Technical Review Committee

**CITY OF DELAND
THURSDAY MARCH 20, 2025 AT 1:30 P.M.
CITY OF DELAND TRC MEETING ROOM
DELAND, FLORIDA**

City of DeLand
SP24-198
DUPONT
WAREHOUSE

City of DeLand
SP25-007
HULLEY TOWER,
STETSON

City of DeLand
PSB25-015
BERESFORD RESERVE
PD

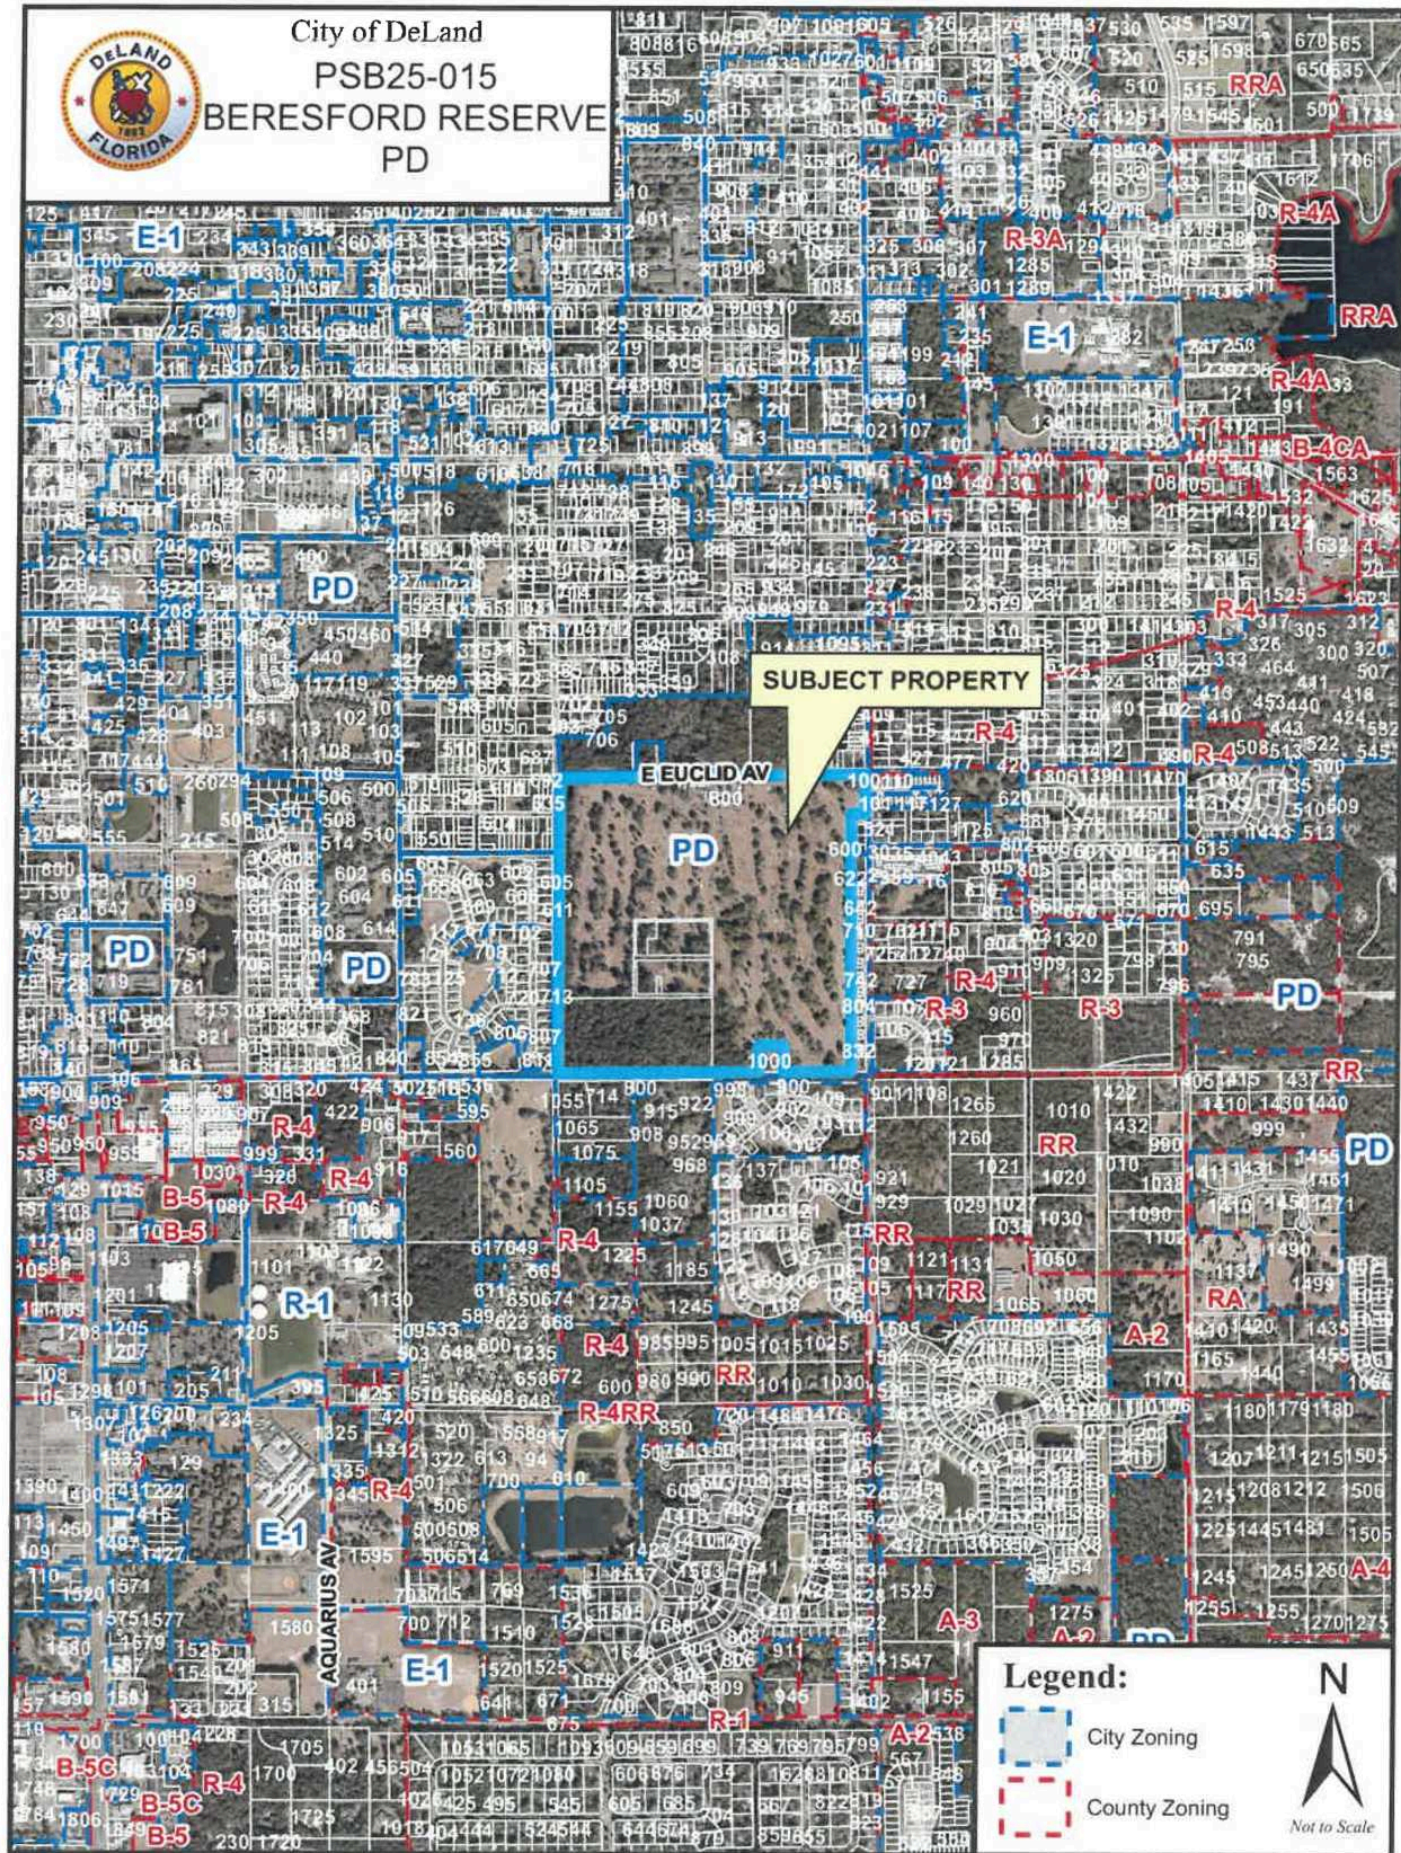
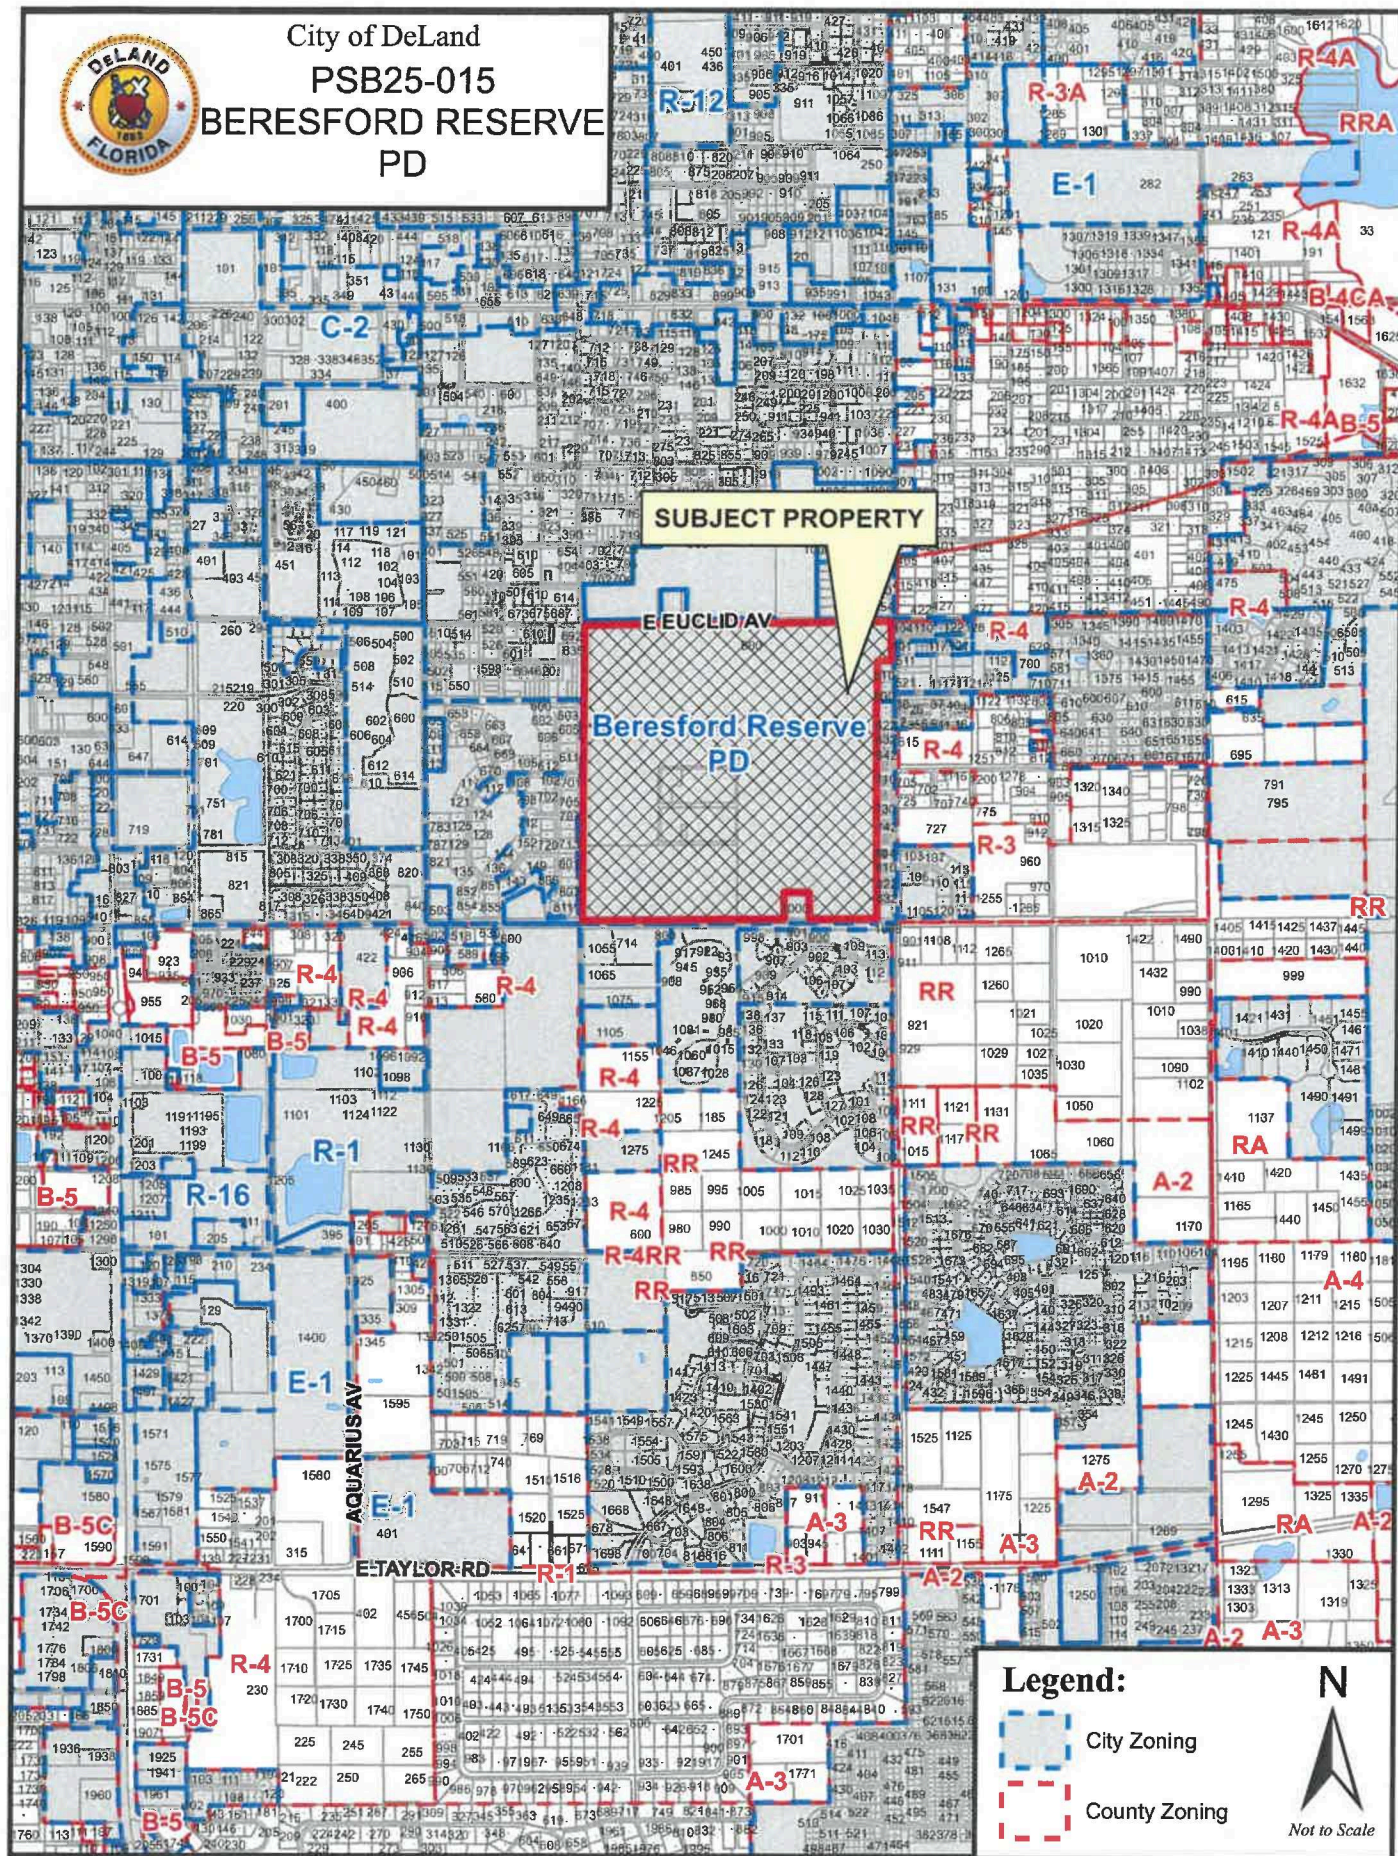
Discipline	Status	Details	Attached To	Created By	Last Updated By	Modifications Required
Engineering	Draft	Volusia County Permit Provide a Volusia County Right of Way Use Permit prior to issuance of the Infrastructure Permit.	C4.9.1	Steven Danskine	Steven Danskine	Yes
Engineering	Draft	Stormwater Please provide peak stage elevations for the various modeled storms in each pond profile.	C7.17	Steven Danskine	Steven Danskine	Yes
Engineering	Draft	Conflicting Callouts Various callouts, i.e. Unit No. and FFE overwrite each other making it difficult to read and interpret. Please review for clarity.	C7.10	Steven Danskine	Steven Danskine	Yes
Engineering	Draft	Display Various line types including existing contours and proposed elevations are very difficult to discern and are not reflected in the Legend.	C7.5	Steven Danskine	Steven Danskine	Yes
Engineering	Draft	Storm Ponds The Drainage Report identifies a proposed Pond C located in the northeast quadrant that does not appear in the grading sheets. Please review and revise as appropriate.	Beresford Reserve - Drainage Report.pdf	Steven Danskine	Steven Danskine	Yes

Engineering	Draft	Mail Kiosks It is unclear if or where mail kiosks may be utilized. Mail Kiosks will require handicapped accessible parking and ADA compliant paths between vehicles and the kiosk.	C4.5	Steven Danskine	Steven Danskine	Yes
Engineering	Draft	Pond C The Drainage Report identifies a proposed Pond C located in the northeast quadrant that does not appear in the grading sheets. Please review and revise as appropriate.	C7.0	Steven Danskine	Steven Danskine	Yes
Engineering	Draft	Errant Symbolology There are various dashed lines and square symbols that are not represented in the Legend on this sheet and subsequent sheets. Please review and revise accordingly.	C7.3	Steven Danskine	Steven Danskine	Yes
Engineering	Draft	Vertical Datum Vertical elevations shall be based upon the North American Vertical Datum 1988 (NAVD-88).	C1.1	Steven Danskine	Steven Danskine	Yes

Discipline	Status	Details	Attached To	Created By	Last Updated By	Modifications Required
Engineering	Draft	As-Builts As-Built information for all infrastructure shall be submitted to the City in electronic format in .pdf, .dwg, and GIS formats for review and approval prior to acceptance by the City. All such submittals shall be electronically signed and sealed by the Engineer of Record or a licensed surveyor.	C1.0	Steven Danskine	Steven Danskine	Yes
Fire	Draft	Fire Hydrants 1. Move or add an additional hydrant in area indicated. 2. Add hydrant on road E.	C9.0	Jamie Lunsford	Jamie Lunsford	Yes
Forestry	Draft	Historic Tree Barricade Detail You will most likely be preserving historic trees on this site. You will need to add the City's Historic Tree Barricade Detail to the plan. The locations of the tree barricades will also need to be shown on the plans.	L1.50	Kit Dennis	Kit Dennis	Yes
Forestry	Draft	Detail 10 - Tree Protection Fencing Please replace this detail with the City's Typ Tree Barricade Detail. It can be found on the City website.	L1.50	Kit Dennis	Kit Dennis	Yes

Forestry	Draft	Understory Trees In order to meet grade 1 standards for the specified calipers, please change the height to 9' and spread to 5' on the Japanese Privet and Tuskegee Grape Myrtle.	L1.00	Kit Dennis	Kit Dennis	Yes
Forestry	Draft	Canopy Trees 1) In order to meet grade 1 standards for the specified calipers, please change the height specification to 8' for all of the canopy trees. 2) Please change the spread specification for the Bracken's Beauty Southern Magnolia and Drake Elm to 2' in order to meet grade 1 standards for the specified calipers.	L1.00	Kit Dennis	Kit Dennis	Yes
Forestry	Draft	2.5" Caliper Trees You have three trees listed that do not meet our minimum size specifications. Please increase the size of the Dahoon Holly, Nellie Stevens Holly, and Little Gem Magnolia to 3" caliper if you want them to count towards mitigation and minimum coverage requirements.	L1.00	Kit Dennis	Kit Dennis	Yes

Forestry	Draft	Date Palm (Phoenix Dactylifera) Date Palm is not an approved replacement tree and will not be counted towards mitigation or coverage requirements.	L1.00	Kit Dennis	Kit Dennis	Yes
Forestry	Draft	"Street Trees" The City does not allow trees to be planted within the public right of way, unless there is an agreement in place as to who will be responsible for the trees, and any damages the trees cause to public infrastructure. If an agreement is made, you will most likely need to make some modifications to the planting locations based on line-of-sight issues, and distance from items such as fire hydrants and storm water inlets.	L1.00	Kit Dennis	Kit Dennis	Yes

Discipline	Status	Details	Attached To	Created By	Last Updated By	Modifications Required
Forestry	Draft	Lot Tree Table Please provide a table that indicates the number of trees that will be on each lot. Lots require one tree per 2500sqft. Each lot must include a front yard canopy tree.	L1.00	Kit Dennis	Kit Dennis	Yes
Forestry	Draft	Historic Tree Mitigation None of the proposed trees with meet the minimum specifications for historic tree replacement. I cannot determine what the required mitigation will be until the requested tree information has been received. For future submittals, please be aware that historic trees that are approved for removal require 100% DBH replacement, and that the minimum size trees accepted for historic mitigation are 6" caliper, and 17' height.	L1.00	Kit Dennis	Kit Dennis	Yes
Forestry	Draft	Right of Way Trees The City does not allow trees to be planted within the public right of way, unless there is an agreement as to who will be responsible for the maintenance of the trees, and for the repairs to public infrastructure that the trees damage.	C4.0	Kit Dennis	Kit Dennis	Yes

Forestry	Draft	Tree Protection Area 15% of the site is required to be designated as Tree Protection Area (TPA). Please include the TPA's on your overall site plan.	C4.0	Kit Dennis	Kit Dennis	Yes
Forestry	Draft	Trees and Vegetation Note 1. This note does not reference a sheet that has been provided. Please have it reference sheet L1.50, which contains the Tree Barricade Detail. That detail will need to be replaced with the City's Typ Tree Barricade Detail. The detail can be found on the City website.	C1.0	Kit Dennis	Kit Dennis	Yes
Forestry	Draft	Landscape Plans Please add the Landscape sheets to the Sheet List Table.	C0.0	Kit Dennis	Kit Dennis	Yes
Forestry	Draft	Irrigation Plan An irrigation plan is required.	C0.0	Kit Dennis	Kit Dennis	Yes
Forestry	Draft	Tree Protection Area 15% Tree Protection Area is required and must be placed in tracts.	C4.12	Kit Dennis	Kit Dennis	Yes
Forestry	Draft	Tree Mitigation Mitigation requirements cannot be determined until the requested tree survey and removal information is provided.		Kit Dennis	Kit Dennis	Yes

Discipline	Status	Details	Attached To	Created By	Last Updated By	Modifications Required
Planning	Draft	Rear Loaded Alley Architecture Please provide larger front porch amenity areas for the rear loaded housing products.		Christopher Carson	Christopher Carson	Yes
Planning	Draft	Sign Please show sign location. Sign requires separate building permit prior to construction.		Christopher Carson	Christopher Carson	Yes
Planning	Draft	Sidewalk Modify all crosswalks to decorative permeable pavers	C4.9	Christopher Carson	Christopher Carson	Yes
Planning	Draft	Architecture Provide elevations for the townhome units. Be sure to label elevations materials and dimensions.		Christopher Carson	Christopher Carson	Yes
Planning	Draft	Easements Please label and dimension all existing and proposed easements.		Christopher Carson	Christopher Carson	Yes
Planning	Draft	Tree Survey A tree survey is required. Please provide a full tree survey with the resubmittal.		Christopher Carson	Christopher Carson	Yes

Planning	Draft	Signed & Seal Be sure to sign & seal all sheets.	L1.00	Christopher Carson	Christopher Carson	Yes
Planning	Draft	Resubmittals Please note, a resubmittal may result in additional comments if plans did not provide enough detail to complete the review, or if substantial changes are required based on staff comments. Applicant initiated changes may also result in additional comments.		Christopher Carson	Christopher Carson	Yes
Planning	Draft	Amenity Details Provide details on all amenity areas including clubhouse and pocket parks.	C4.0	Christopher Carson	Christopher Carson	Yes
Planning	Draft	Townhome Units Provide dimensions for the individual townhome lot lines.	C4.4	Christopher Carson	Christopher Carson	Yes
Planning	Draft	Setback dimensions Be sure all setbacks are able to be determined quickly and easily by dimensioning all setbacks. Example shown.	C4.4	Christopher Carson	Christopher Carson	Yes

Planning	Draft	Parking stalls Parallel on-street parking must meet the City's parking dimensions of 9 x 22. Revise all on-street parking spaces to meet.	C4.2	Christopher Carson	Christopher Carson	Yes
Planning	Draft	Park PD park for the public must be constructed with Phase 1 per PD.	C4.0	Christopher Carson	Christopher Carson	Yes
Planning	Draft	Architecture The same architectural style cannot be used for both the 6 and the 8-unit townhomes. Please revise the architecture to comply with the Community Design Standards, Section	C4.0	Christopher Carson	Christopher Carson	Yes

Discipline	Status	Details	Attached To	Created By	Last Updated By	Modifications Required
33-94. Varied rooflines/ridge line is required. Please see attached ordinance clarifying the monotony section of the regulations along with a requirement for detailed architectural elevations depicting compliance with the Community Design Standards.						
Planning	Draft	Sidewalks Provide sidewalks along S. Boston Avenue, E. Euclid Ave. & S. Hill Avenue.	C4.0	Christopher Carson	Christopher Carson	Yes
Planning	Draft	Townhomes Units Townhome Units cannot exceed 150' in length. Please revise the layout to meet.	C4.4	Christopher Carson	Christopher Carson	Yes
Planning	Draft	Max ISR Maximum ISR for townhomes units is 50 %. The layout seems like it will exceed.	C4.4	Christopher Carson	Christopher Carson	Yes
Planning	Draft	Pedestrian Connection Provide pedestrian connection from cul-de-sac to Hill.	C4.3	Christopher Carson	Christopher Carson	Yes

Planning	Draft	Pedestrian Crossing Provide decorative pedestrian crosswalks wherever a sidewalk creates a tangent with the roadway to another sidewalk.	C4.2	Christopher Carson	Christopher Carson	Yes
Planning	Draft	Landscape Buffer Extend the landscape buffer along the entire Euclid Ave. facade and adjust quantities.	L1.00	Christopher Carson	Christopher Carson	Yes
Planning	Draft	Park Provide details of Park and all pocket parks. What sort of equipment or amenities are provided. Please include dimensions and details if playground equipment, dog park, or other formal amenities are provided.	C4.9	Christopher Carson	Christopher Carson	Yes
Planning	Draft	12' Concrete Sidewalk Please show the trail extended to S. Hill Avenue and remove gap along Beresford.	C4.9	Christopher Carson	Christopher Carson	Yes
Planning	Draft	Site Data Table Please make site data table fully transparent and QC. Zoning is PD for example.	C4.0	Christopher Carson	Christopher Carson	Yes

Planning	Draft	Typical Lot Provide typical lot for townhome units. Include driveway dimensions, setbacks, and landscaping for a typical townhome building.	C4.0	Christopher Carson	Christopher Carson	Yes
Planning	Draft	Preliminary Plat - Sheet C4.14 Please provide detailed plan for the City Park Tract. Tract shall be developed under separate site plan. Coordinate with Rick Hall for site design.	C4.14	Christopher Carson	Christopher Carson	Yes
Planning	Draft	Preliminary Plat - Tracts Please separate drainage and TPA's into stormwater tracts and TPA tracts respectively.	C4.12	Christopher Carson	Christopher Carson	Yes
Utilities	Draft	Update Details Sheet 10.0 -10.4 all needed update to 12/30/2024 dated details.	C10.0	Jim Ailes	Jim Ailes	Yes

Discipline	Status	Details	Attached To	Created By	Last Updated By	Modifications Required
Utilities	Draft	Water Connection Beresford water connection is shown as a MJ tee and needs to be a wet tap and valve with fittings called out.	C9.9	Jim Ailes	Jim Ailes	Yes
Utilities	Draft	Reclaim Service Service is coming off of the water main.	C9.8	Jim Ailes	Jim Ailes	Yes
Utilities	Draft	Common Area How will this area be irrigated with reclaim water?	C9.8	Jim Ailes	Jim Ailes	Yes
Utilities	Draft	Reclaim Service How will this service be feed?	C9.8	Jim Ailes	Jim Ailes	Yes
Utilities	Draft	Reclaim Line ends but no fittings called out.	C9.8	Jim Ailes	Jim Ailes	Yes
Utilities	Draft	Water Water main stops and not fittings or sizes shown.	C9.8	Jim Ailes	Jim Ailes	Yes
Utilities	Draft	Sewer slope Most of the Townhome section sewer main is being installed at minimum slope.30	C9.7	Jim Ailes	Jim Ailes	Yes
Utilities	Draft	Reclaim Show how reclaim will irrigate the Townhome section.	C9.7	Jim Ailes	Jim Ailes	Yes

Utilities	Draft	Reclaim Show the proposed fittings and close out of the reclaim line on western end of Road T.	C9.6	Jim Ailes	Jim Ailes	Yes
Utilities	Draft	Water Line Show and call out fittings for the western end of Road T water main.	C9.6	Jim Ailes	Jim Ailes	Yes
Utilities	Draft	Utility Separation Water and reclaim lines on same side of road instead of opposite. Separation will need to be maintained for acceptance.	C9.5	Jim Ailes	Jim Ailes	Yes
Utilities	Draft	Reclaim No reclaim connection shown for Townhome area.	C9.4	Jim Ailes	Jim Ailes	Yes
Utilities	Draft	Sewer Minimum slope	C9.4	Jim Ailes	Jim Ailes	Yes
Utilities	Draft	Sewer Connection Boston The manhole on Boston is a proposed new MH? Slope is at minimum propose grade. Also it will be follow against the flow direction on a large gravity flow pipe and will get surcharged. Un acceptable.	C9.4	Jim Ailes	Jim Ailes	Yes

Discipline	Status	Details	Attached To	Created By	Last Updated By	Modifications Required
Utilities	Draft	Boston Water Connection What is the proposed method to connect to the water main on Boston and show fittings.	C9.4	Jim Alles	Jim Alles	Yes
Utilities	Draft	Reclaim Main Show how pipe will be finished.	C9.3	Jim Alles	Jim Alles	Yes
Utilities	Draft	Water Call out water main size and show how it will be finished off. No fittings called out.	C9.3	Jim Alles	Jim Alles	Yes
Utilities	Draft	Seperation Water and reuse being placed on same side of Road A, which is not typical. Proper separation is required or switch one of the to west side of road.	C9.2	Jim Alles	Jim Alles	Yes
Utilities	Draft	Reuse Please call out reuse line, size, and connection.	C9.1	Jim Alles	Jim Alles	Yes
Utilities	Draft	USA This project will require a Utility Service Agreement.	C0.0	Jim Alles	Jim Alles	Yes
